# TECHNICAL BULLETIN

June 30, 2021

## DCW Counterweight

Support Angles

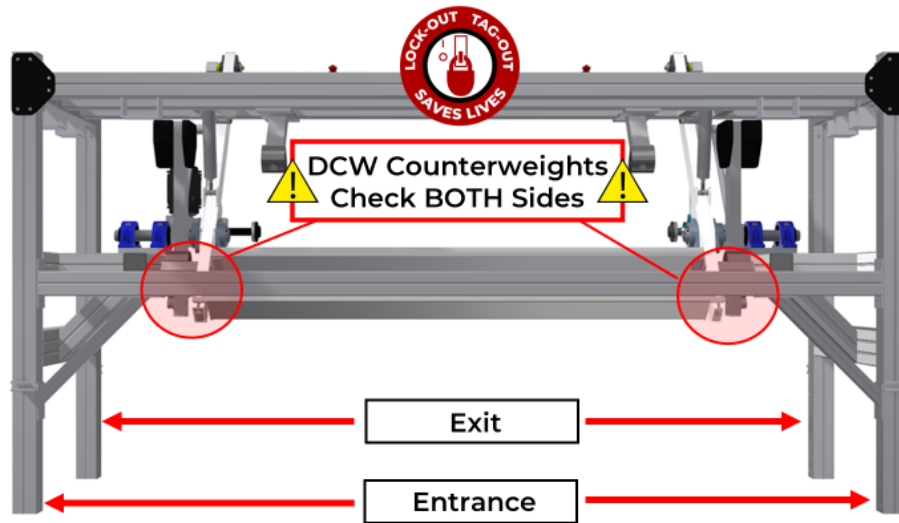
**Corners Can NOT Be Sharp**

**WARNING: If 3 Sharp Corners are found Immediately wrap 3 Ratchet Straps around Counterweight and Frame, and Counterweight Assembly MUST be Replaced.**

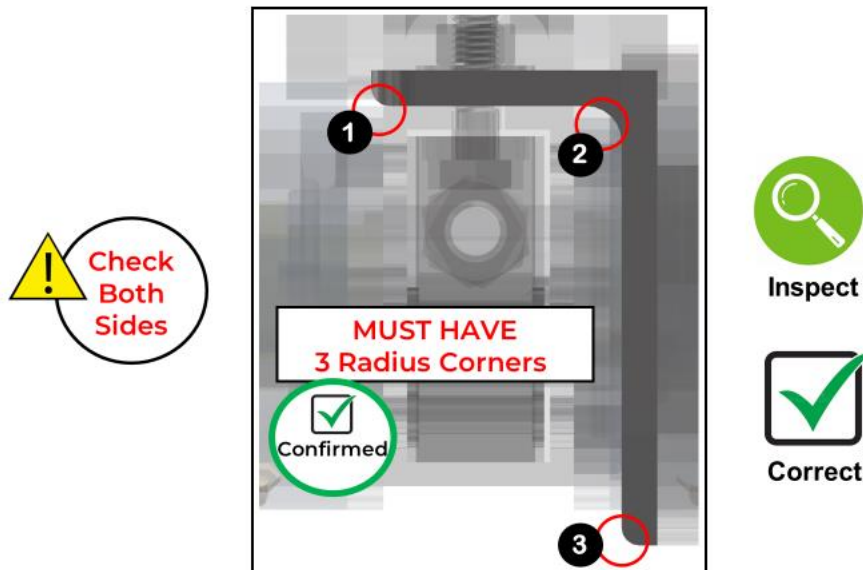
4. If the Counterweight Assembly Component has a Structural Angle with **3 Radius Corners**, the Support Angles are **Correct**.

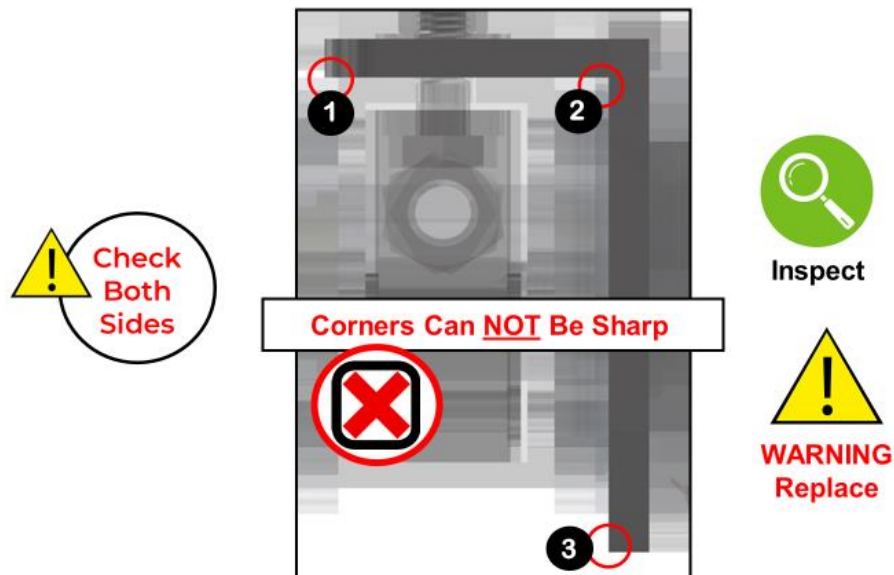
5. If the Counterweight Assembly Component has an Architectural Angle with **3 Sharp Corners**, the **Counterweight Assembly MUST Be Replaced**.

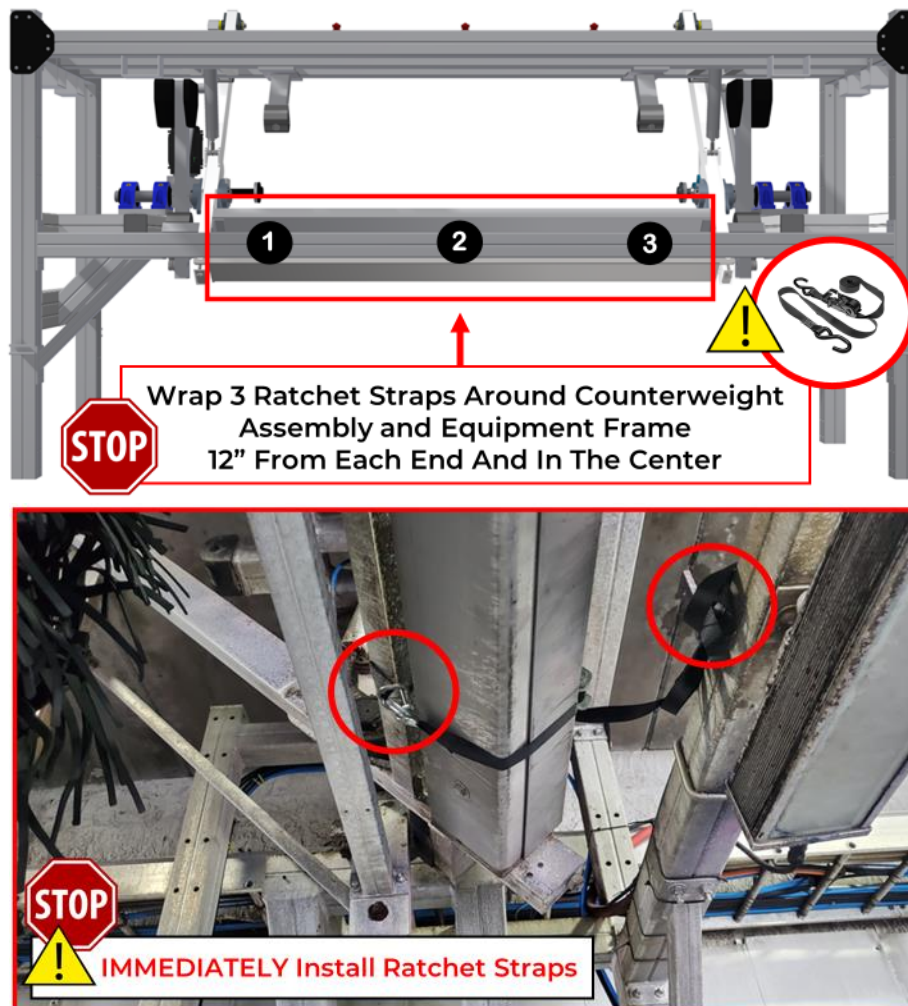
6. As a **Safety Precaution**, wrap **3 Ratchet Straps** around Counterweight Assembly **and** Equipment Frame, 12" from each end and in the center.

**!** **WARNING:** 3 Ratchet Straps **MUST** Be Installed **IMMEDIATELY** if the Counterweight Assembly Support Angles have an Architectural Angle (3 sharp corners); to prevent an accident. This **MUST** be done as a Preventive Measure until the Counterweight Assembly can be Replaced.
